ADDENDUM NO. 3

DATE: October 17, 2019

**VILLAGE OF ELWOOD, ILLINOIS
WATER SYSTEM IMPROVEMENTS
WATER TREATMENT PLANT SOFTENER ADDITION**

UNDERDRAIN SUPPORT DETAIL

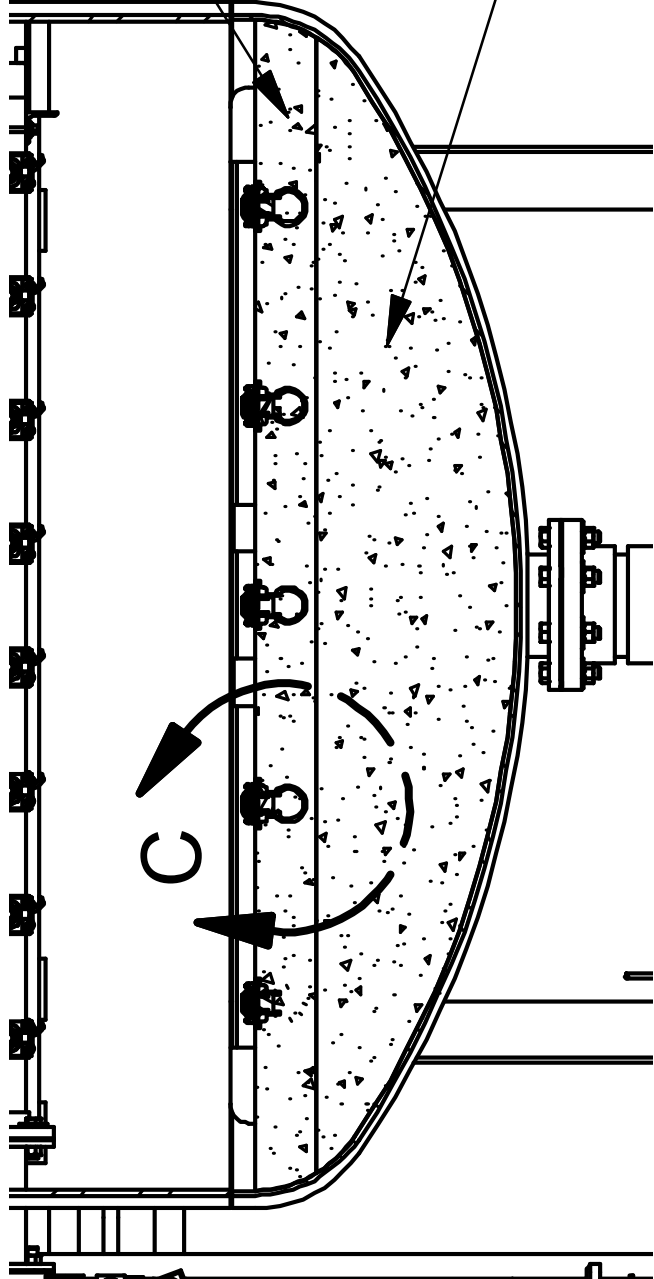
- A. The following clarifications are being provided to assist the Contractor in preparing costs related to the underdrain replacement within the two existing softening vessels:
1. See attached drawings provided by WesTech Engineering which shows the steel underdrain construction and installation of the grout. Please contact WesTech Engineering for further clarifications if needed. (Darrell Christianson, 515.268.8557).
 2. Contractor is responsible for repairs to vessel coating damaged as part of the underdrain modifications. Contact Erik Otten, Taylor Coatings, (Cell: 708.822.8323) for specific surface preparation and coating materials.
 3. Provide type of grout fill specified by WesTech Engineering.
 4. The existing two vessels are ASME Code with Stamp.

1:2 1/2 (GROUT) MIX
(NON-SHRINK)
TO TOP OF RED CAPS
(BY OTHERS)

1:3:7 (FOUNDATION) MIX
FILL TO 4" BELOW THE
TOP OF THE RED CAPS
(BY OTHERS)
